## Attachment 4 - PLN17/0585 - Engineering comments

**To:** Gary O'Reilly  
**From:** Artemis Bacani  
**Date:** 28 November 2017  
**Subject:** Application No: PLN17/0585  
 Description: Double Storey Building - 10 Dwellings  
 Site Address: 3 Station Street, Fairfield

## Attachment 5 - PLN17/0585 - ESD comments

Responsible Planner:	Gary O'Reilly		
ESD Advisor:	Euan Williamson		
Date:	23.11.2017	Planning Application No:	PLN17/0585
Subject Site:	3 Station Street, Fairfield, VIC		
Site Area:	Approx. 809m <sup>2</sup>	Site Coverage:	100%
Project Description:	Ten dwellings.		
Pre-application meeting(s):	None.

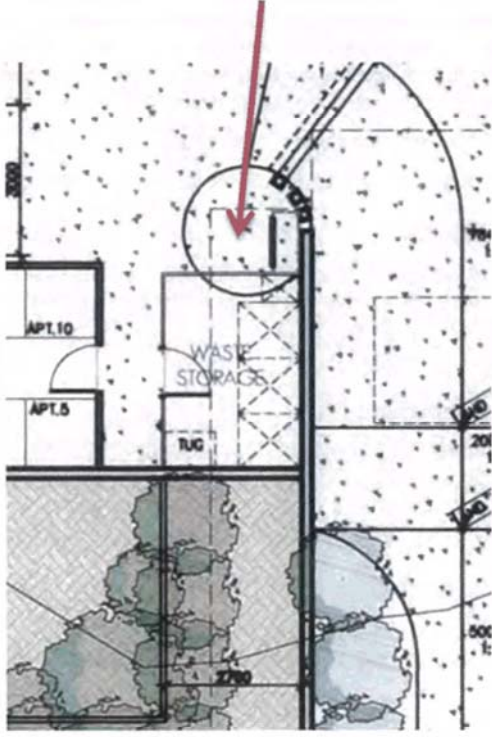
Visitor Parking	The visitor parking spaces should be easily accessible for visitors. It is recommended for the two visitor spaces to be relocated in the spaces that are allocated for apartments 1 and 2.
-----------------	--

Item	Details
Car Space Adjacent to Lift	Applicant to designate the use of this space. Could this space be a visitor space and have a separate space for the car share?
Basement Circular Feature	<p>Information is required on the circular feature shown below.</p>
